Bulker Q&As and CIs on the IACS CSR Knowledge Centre

KC#998

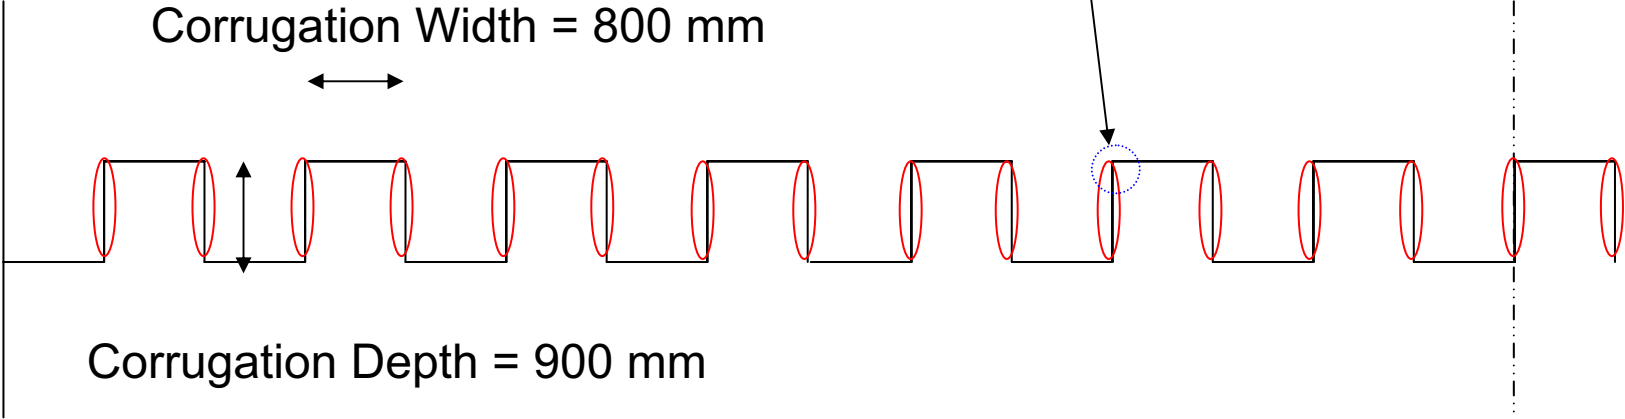
KCID No.	Ref.	Type	Topic	Date completed	Question/CI	Answer	Attachment
998 attc	12/1.2.1.3	Interpretation	Applicability of GRAB requirement	2010/8/4	<p>In a bulk carrier having ship length of 160m around, lower stools may not be fitted below transverse bulkheads and corrugation may be fitted on inner bottom directly.</p> <p>In such cases, GRAB requirement in Ch.12 Sec.1, [2.1.3] is applicable to the lower part of corrugated bulkhead up to 3m above inner bottom.</p> <p>However, GRAB will not contact such corrugation webs due to their configuration as follows;</p> <ul style="list-style-type: none"> - corrugation width and depth are less than 1m, and; - corrugation flanges and webs are perpendicular to each other. <p>Please refer to an arrangement of such a bulk carrier as attached.</p> <p>We are of the opinion that GRAB requirement is not applicable to corrugation webs.</p> <p>Please confirm it.</p>	Grab requirements are not applicable to web of corrugations.	Y

Corrugation flanges and webs are perpendicular to each other.

Grabs do not contact corrugation webs
